**Submission for Compliance with Approval Condition (d) -
the Submission of a Drainage Proposal**

**Proposed Temporary Warehouse (excluding Dangerous Goods Godown) with Ancillary
Facilities for a Period of 3 Years and Filling of Land in "Agriculture" Zone,
Lot 1151 in D.D. 107, Fung Kat Heung, Kam Tin, Yuen Long, New Territories**
(Application No. A/YL-KTN/963)

Appendix I – Response to the Comments of Chief Engineer/Mainland North, Drainage Services Department (CE/MN, DSD)

Drainage Proposal
(Catchment Area and Sections)

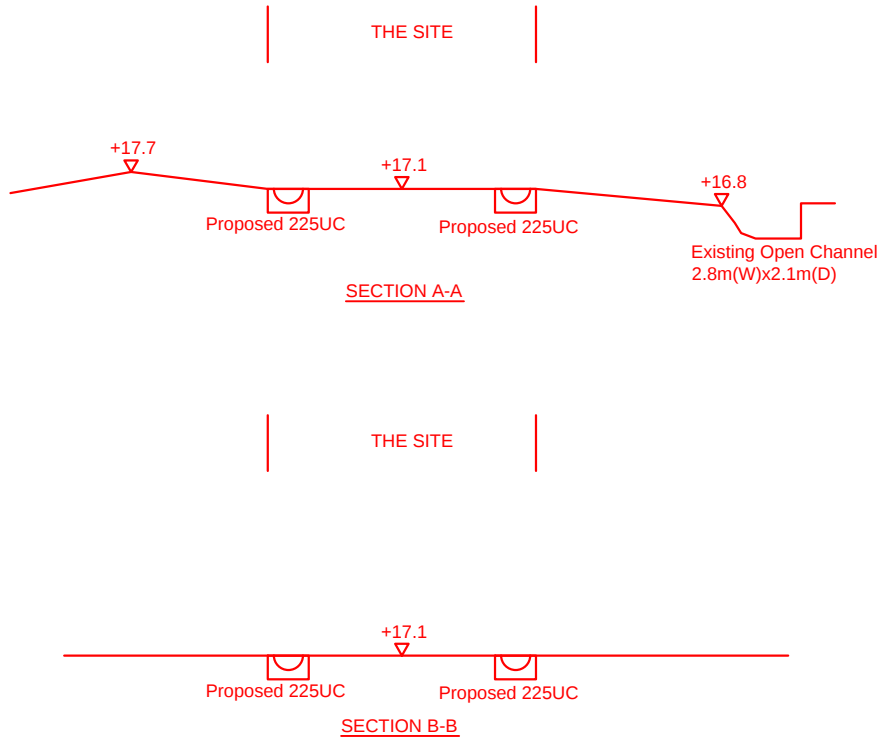
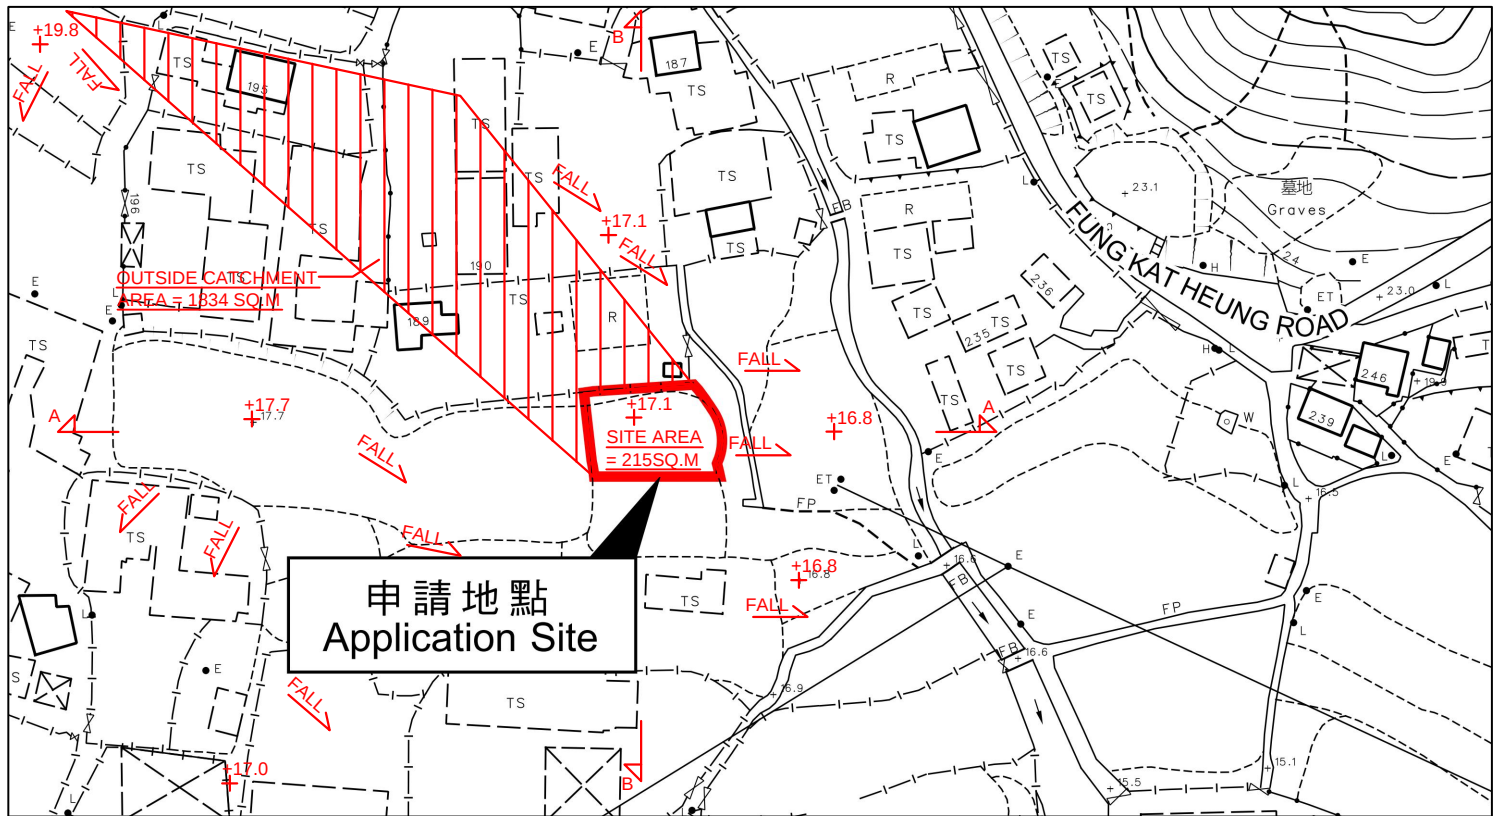
Comments of the CE/MN, DSD (Contact Person: Mr. Terence TANG ; Tel: [REDACTED])		
(i)	For external catchment areas, please justify with photo record the northern side has its own stormwater collection system.	Noted. Please confirm that the catchment area has been reviewed and revised accordingly (Appendix II).
(ii)	External catchment from western side, the whole adjacent land platform should be assumed to be +17.7mPD if no additional information is available for conservative consideration. So that please review the assessment and the proposed u-channel appears to be undersized.	Noted. Please confirm that the assessment has been reviewed and revised accordingly (Appendix II).

Catchment Area (THE SITE) = 215 sq.m (C=0.95)
Outside Catchment Area = 1834 sq.m (C=0.25)

$$Q = 0.278 C_i A$$

$$= 0.278 \times 0.95 \times 250 \times \frac{215}{1000000} + 0.278 \times 0.25 \times 250 \times \frac{1834}{1000000}$$

$$= 0.0461 \text{ m}^3/\text{s}$$

$$= 2764 \text{ lit/min}$$

Provide 225UC (1:100) and 300mm dia. UPVC
Pipe (1:100) is OK
